TN_161 FT4222H Errata Technical Note

Document Reference No.: FT_001198

Version 1.4

The current revision of the FT4222H series is **Revision D, released April 2018.**

Figure 3.2 Quad SPI without Multi Write Phase

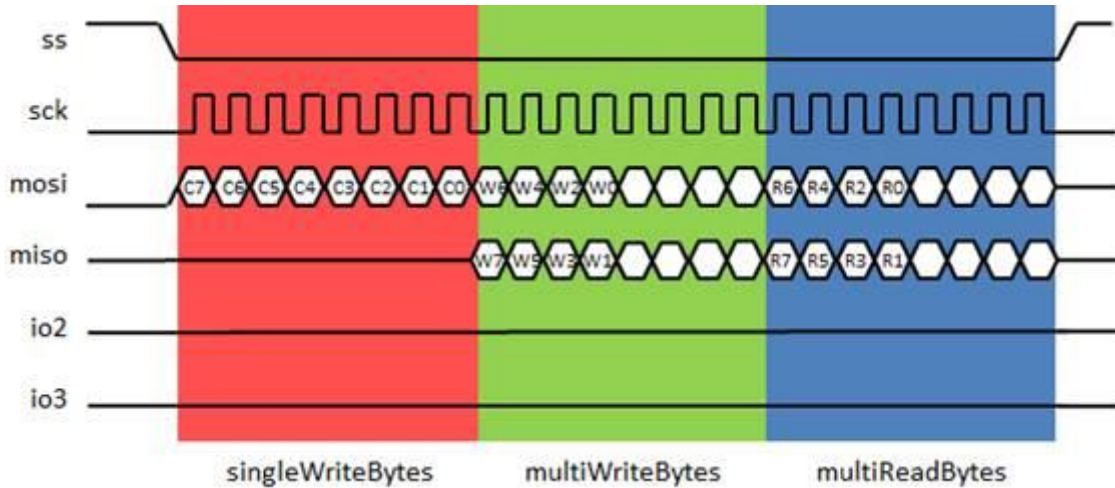
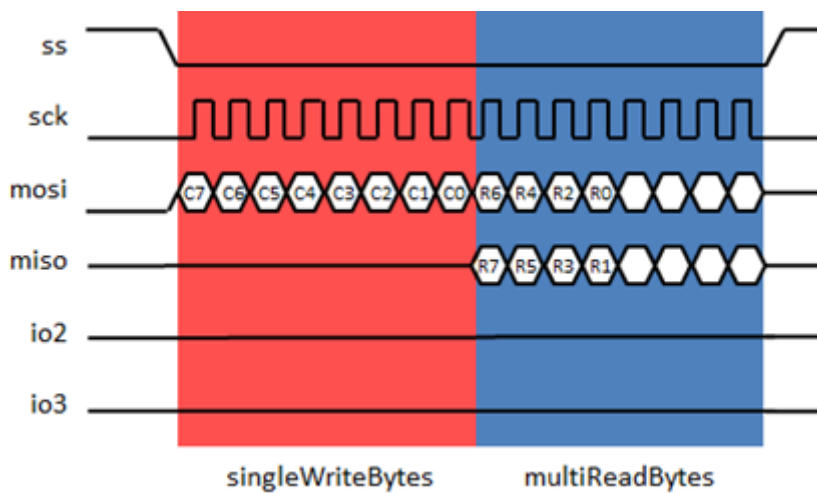
When accessing Toshiba flash with SPI Master Quad mode, FT4222H will hang without giving any responses.

FT4222H operates as master with supporting Dual or Quad SPI with three phases as illustrated in Figure 3.1.

As shown in Figure 1 'C', 'W' and 'R', correspond to "Command Phase", "Write Phase" and "Read Phase", where there are information/data in all three phases that are to be exchanged.

Some flash devices operate with single write and multi read protocol but without the multi write phase as illustrated in Figure 3.2:

Write Phase has no information/data to transfer. This combination of operating mode is not supported with Rev A, B and C.

In SPI Master Quad mode, the operation of single write with quad read was not supported. No workaround was provided, this feature is implemented with Revision D.
